FALLS DAM SITE VISIT REPORT

Inspection 24 April 1985

FALLS DAM SPILLWAY REPAIRS

**FALLS DAM SPILLWAY IMMEDIATE REPAIRS
SPECIFICATION CLAUSES**

SPILLWAY PANEL LOCATIONS

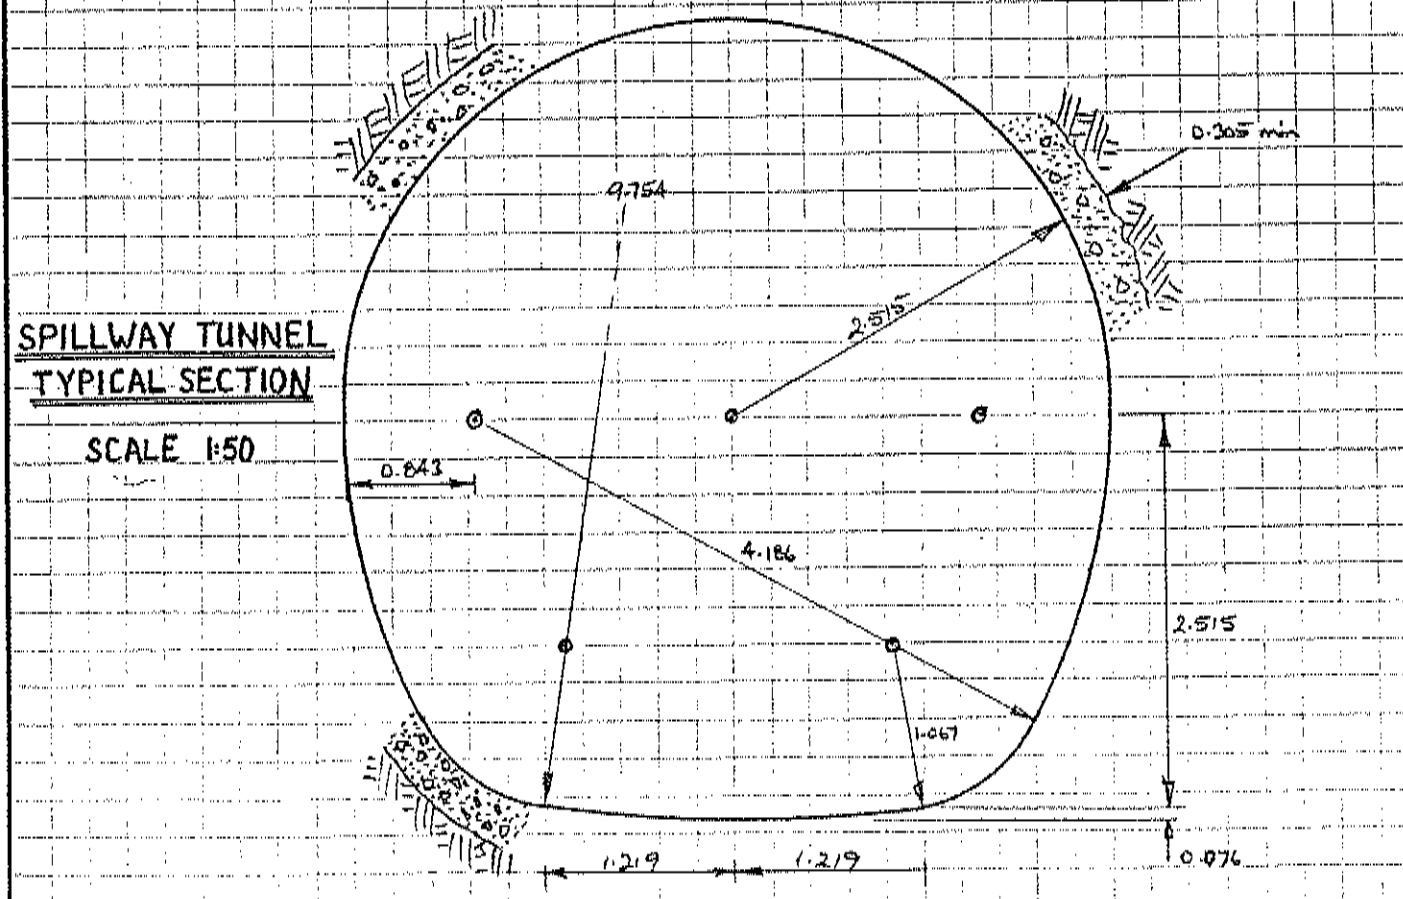
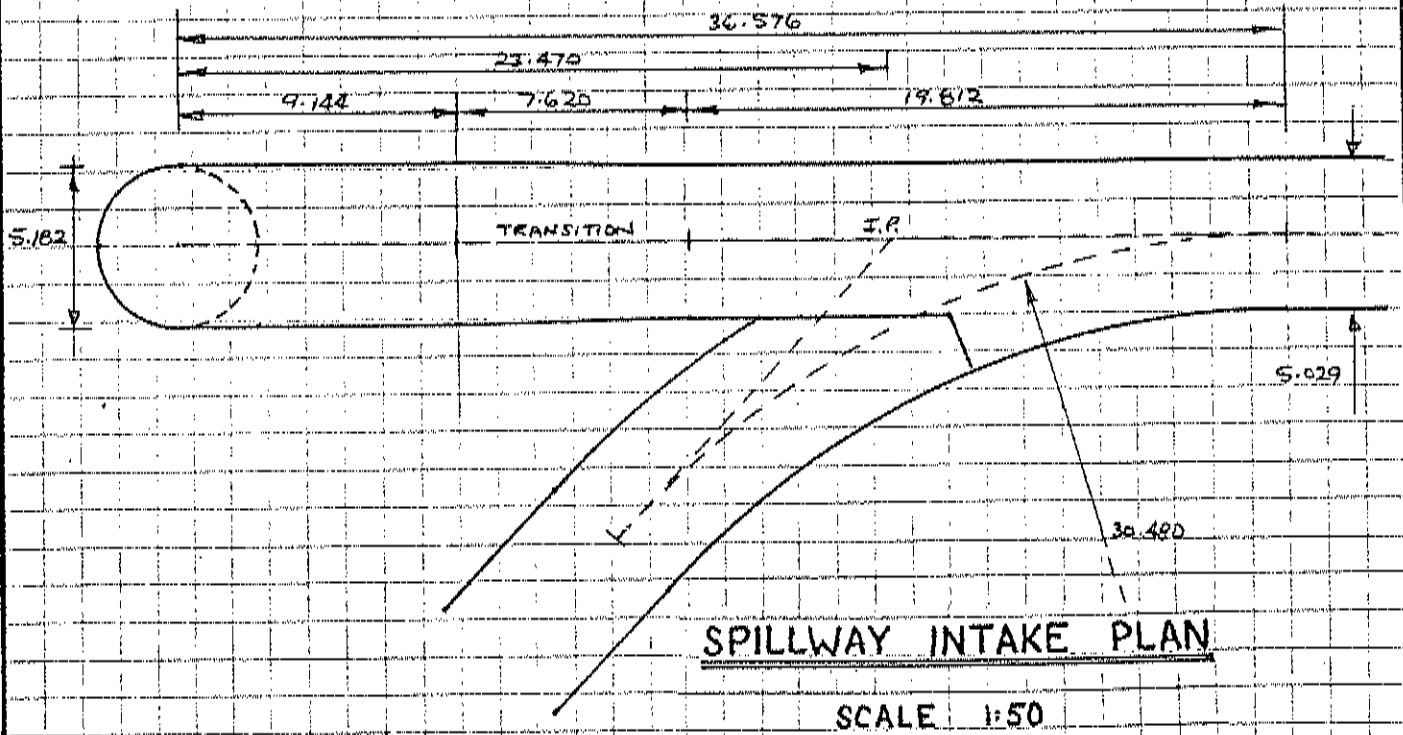
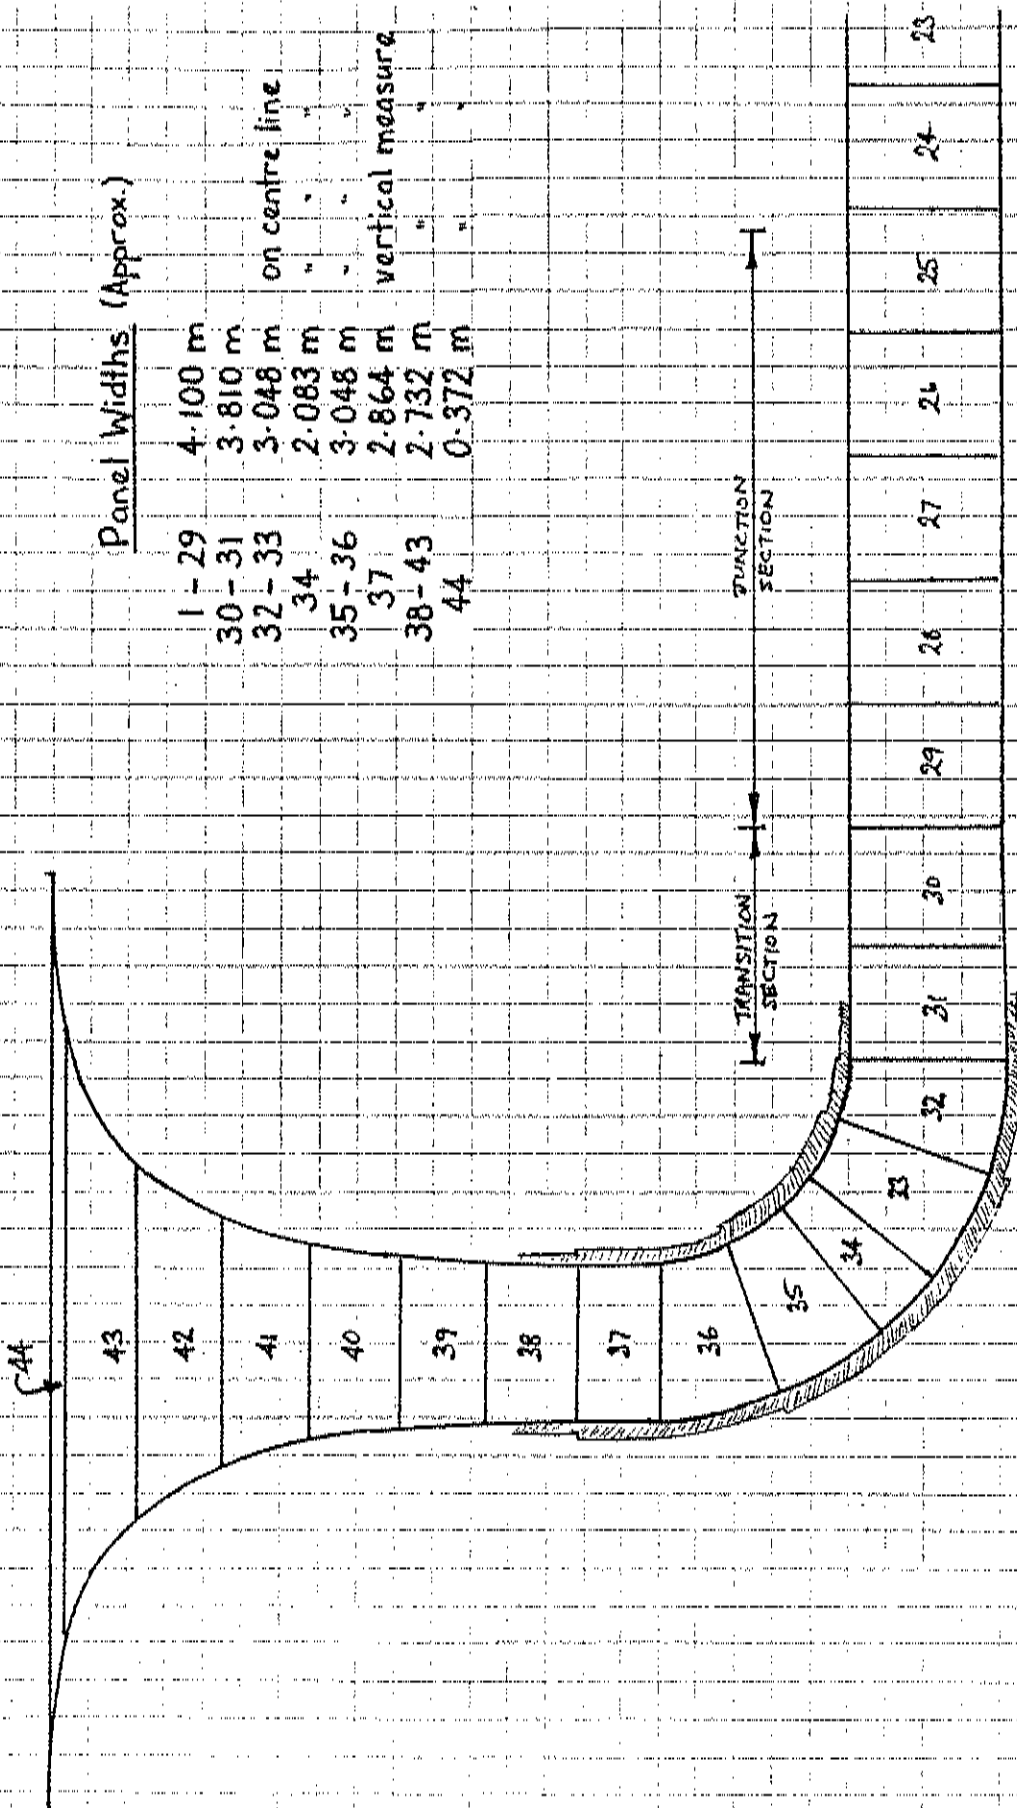
The spillway was inspected beginning from the outlet end. The notes made are made on the basis of the panels (approx 4 m long each) which the concrete lining was placed in. Sketches of the spillway and panel joint locations are appended to this report.

31. CROWN OF PANEL 33, OLD 19mm WEEP HOLE PIPE

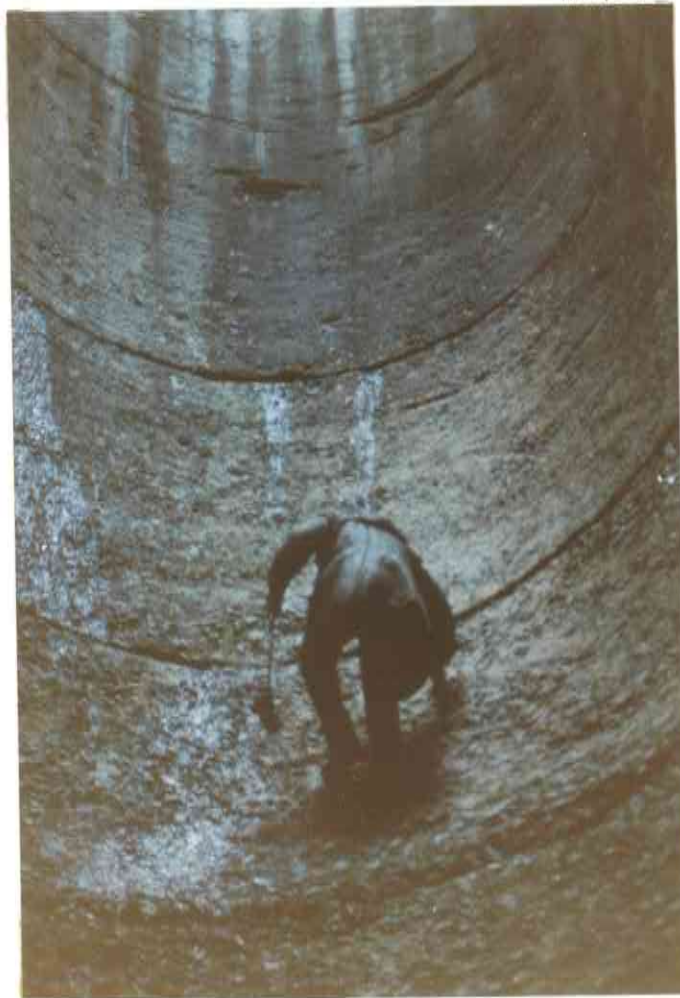
Invert Substantial erosion up to 150 mm deep in places.
Sides Erosion severe up to approx 3/4 height of panel and adjacent to construction jt, especially TL.
Crown Good, old drainage pipe (19 mm) limed up.
Jt 33/34 Severely eroded at invert.

59. PANEL 40 TR DEFECT

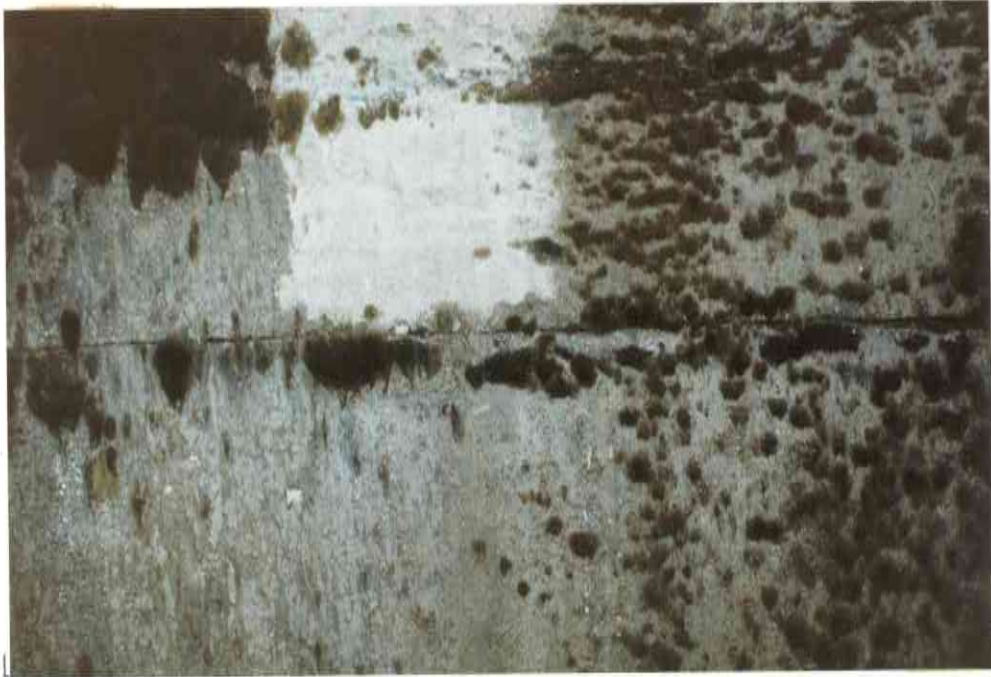
General Spillway flares out significantly, overall condition of panels good generally except for defect TR.
 Side TR Possible construction jt (or concrete gone off too much when placed?), 1.5 m long, 100 mm wide and 150 mm deep, patch required.

77. CLOSE UP OF DAMAGE AT Jt 43/44 BAY 4

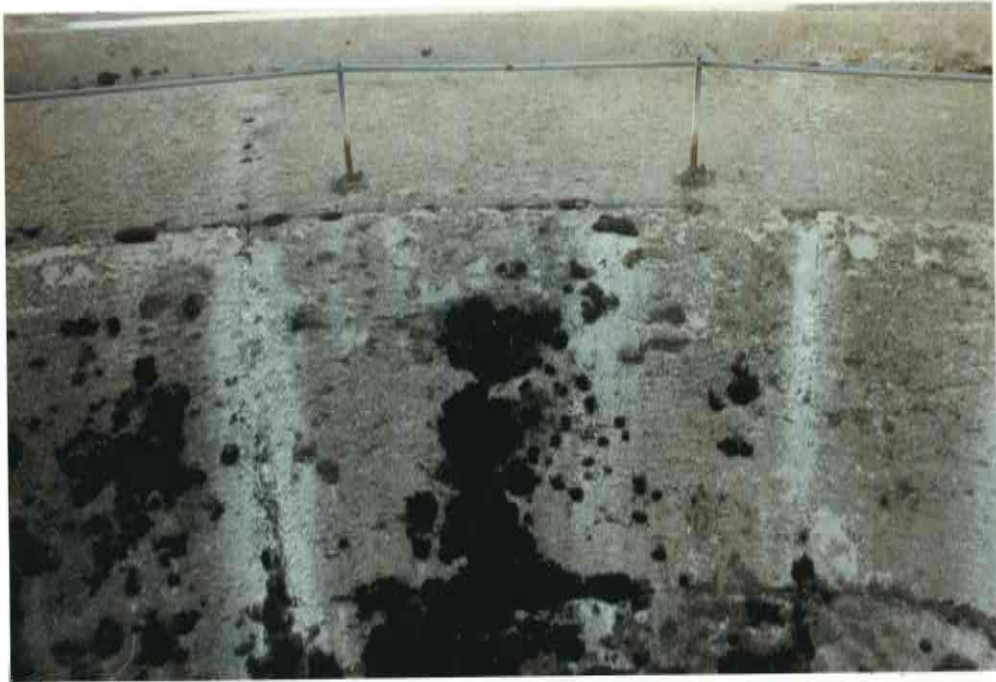
- Photo 73: Bay 1, aggregate exposed 70% area, no steel exposed in panel.
 Photo 74: Bay 2, similar to bay 1.
 Photo 75: Bay 3, more severe erosion, especially down from Jt 43/44. Urgent repair of jt.
 Photo 76: Bay 4, substantial deterioration of central section. Urgent repair.

The most urgent repairs are those noted for panel 43 and joints 43/44 and 41/42. It is recommended that these joints be cleaned, broken back to provide a concrete key and be filled with a stiff mortar.
